CPED STAFF REPORT

CPC Agenda Item #4
November 10, 2014
BZZ-6883

Property Location: 1609 and 1611 Lagoon and 2910 Irving Avenue South
Project Name: Lagoon and Irving Apartments
Prepared By: [Hilary Dvorak](#), Principal Planner, (612) 673-2639
Applicant: Daniel Oberpriller with CPM Development
Project Contact: Scott Nelson with DJR Architecture
Request: To construct a new 6-story, 45-unit residential building.
Required Applications:

GRADING, EROSION CONTROL, & UTILITY PLAN

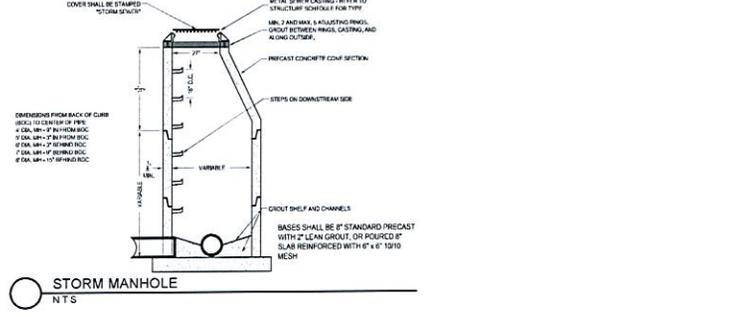
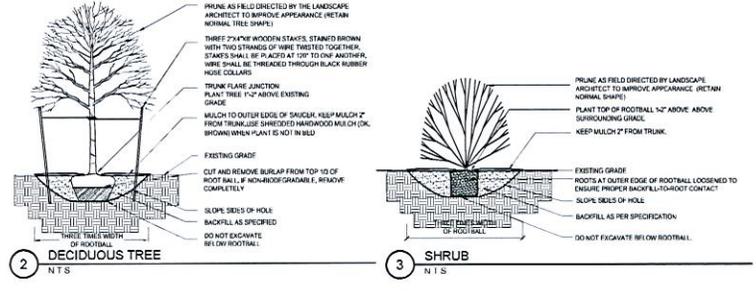
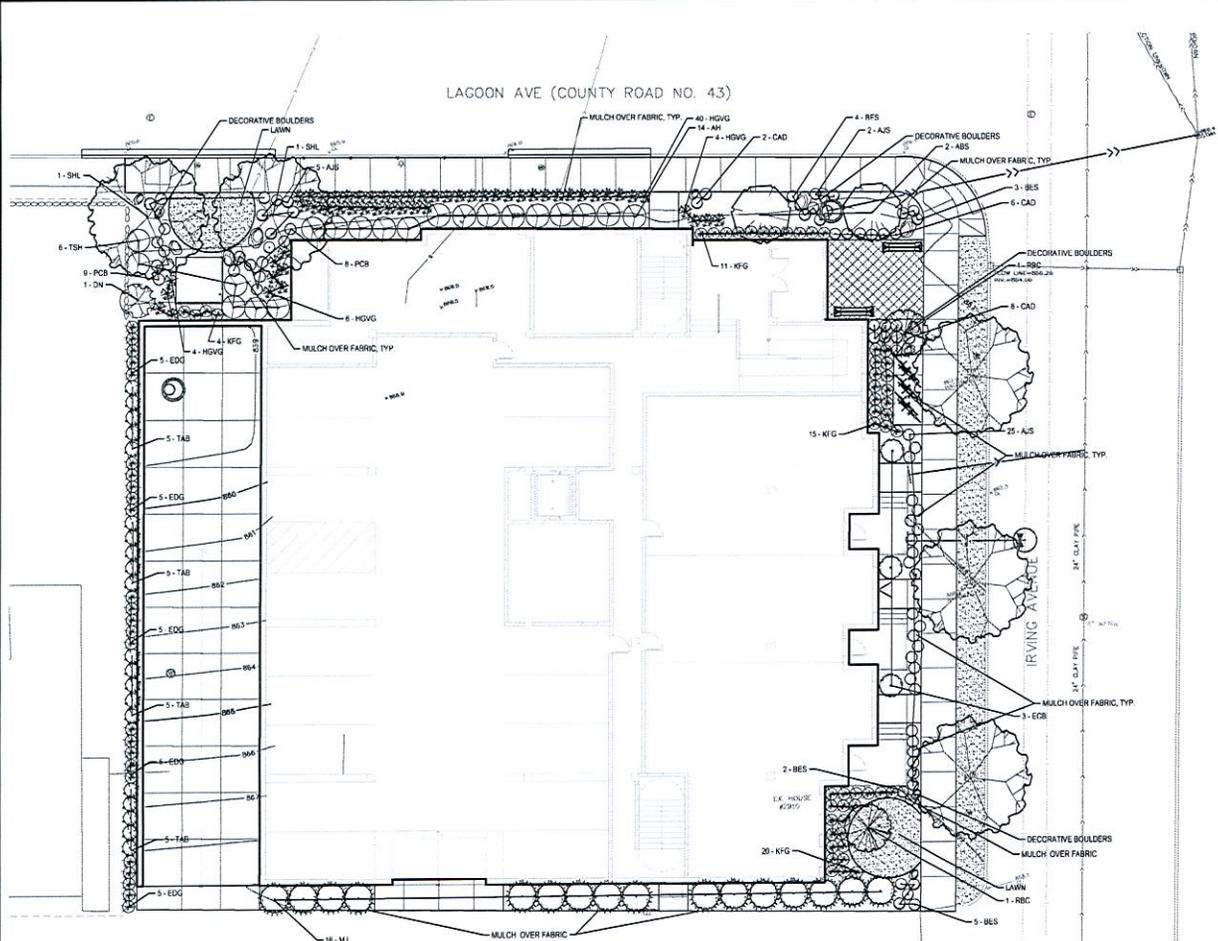
- Please include the property boundaries on Sheet C3.0.
